Joseph M. Farley Nuclear Plant - Unit 2
LER No. 84-006-00

In response to a telephone request by Mr. Norman Merriweather of your staff concerning LER No. 84-006-00 for Farley Nuclear Plant - Unit 2, attached are copies of pertinent design drawings for diesel generator 2B. These drawings show the diesel generator control circuitry before and after modifications made to correct the malfunction reported in LER No. 84-006-00.

TITLE (4)
Diesel Generator Output Breaker Did Not Open After Diesel Tripped

Prior to Modification

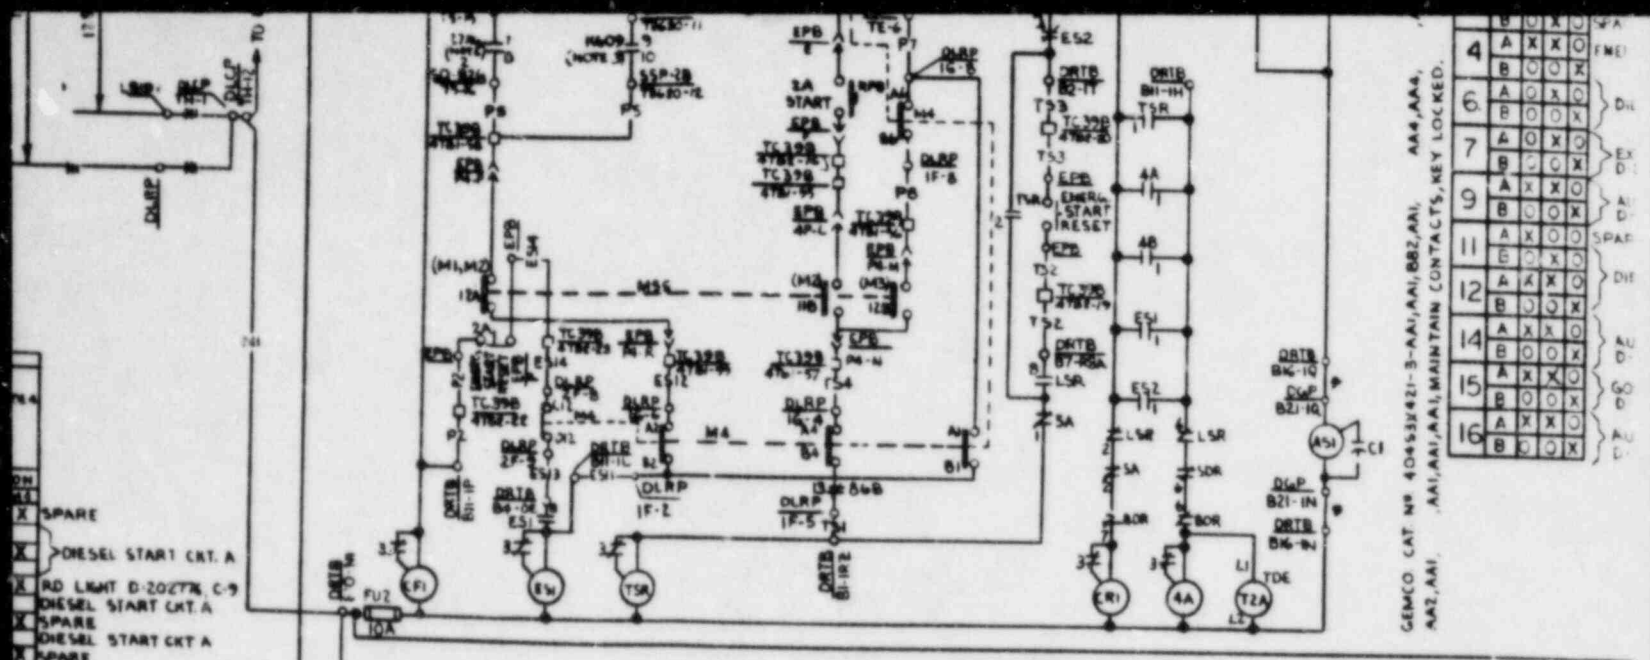
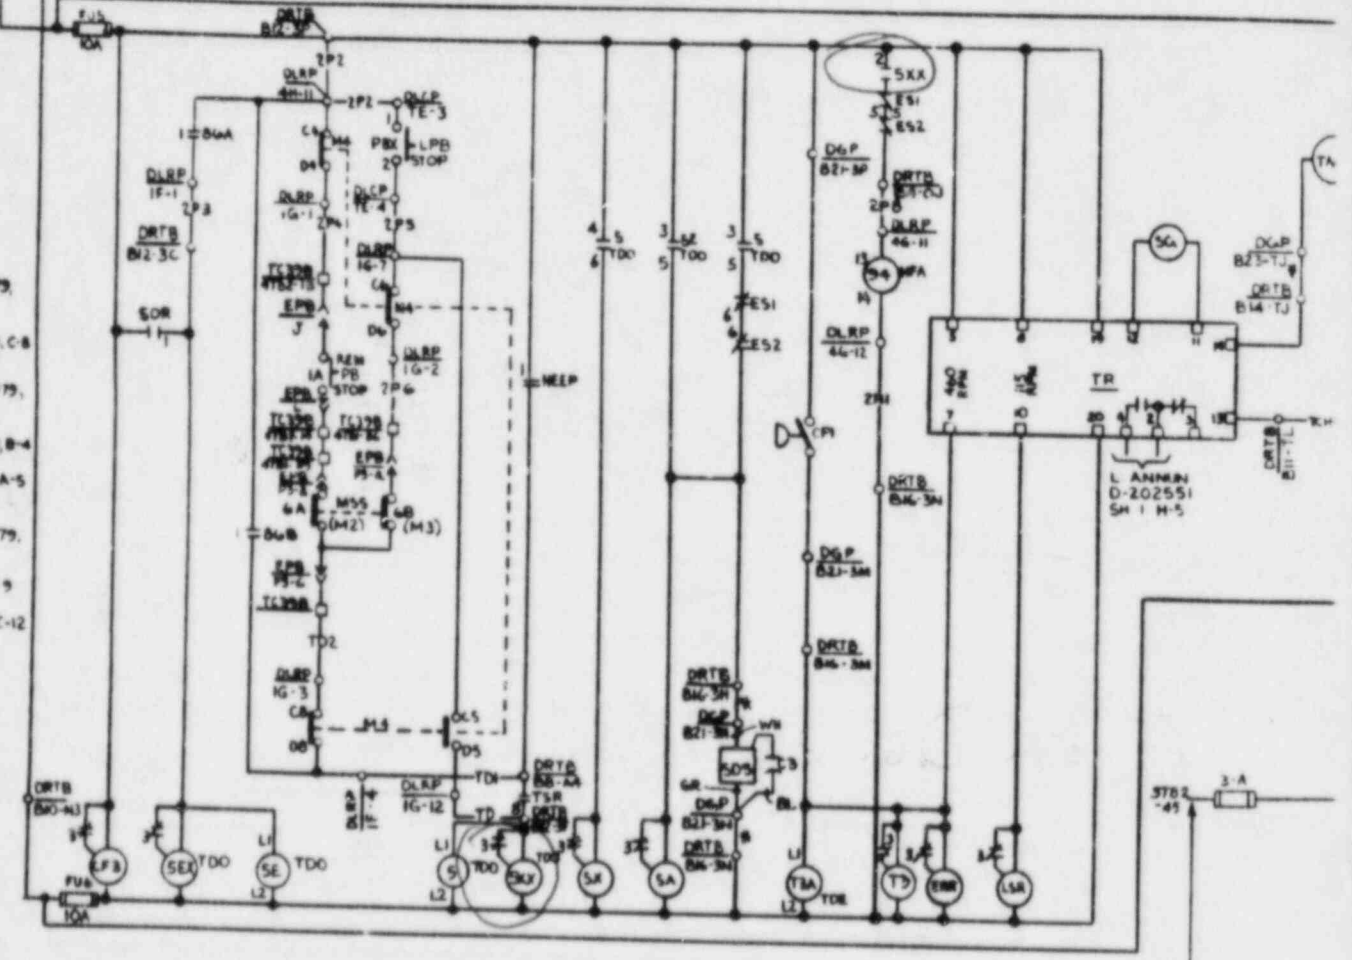
Following a design review, it was determined that, with the existing circuit design, the generator output breaker may or may not have opened if the diesel tripped following a non-emergency test start. Since a certain amount of variance exists in relay actuation times, the trip signal would not have remained in long enough to open the breaker in all cases. Therefore, the generator output breaker might have opened at some times and not at others. This circuitry had been tested during the initial startup testing program and found to operate properly.

Investigation revealed that the remaining four diesel generators incorporated a different circuit design not subject to this condition. The circuit for Diesel Generator 2B was modified to be consistent with the circuits for the other diesel generators. The modified circuitry was tested satisfactorily.
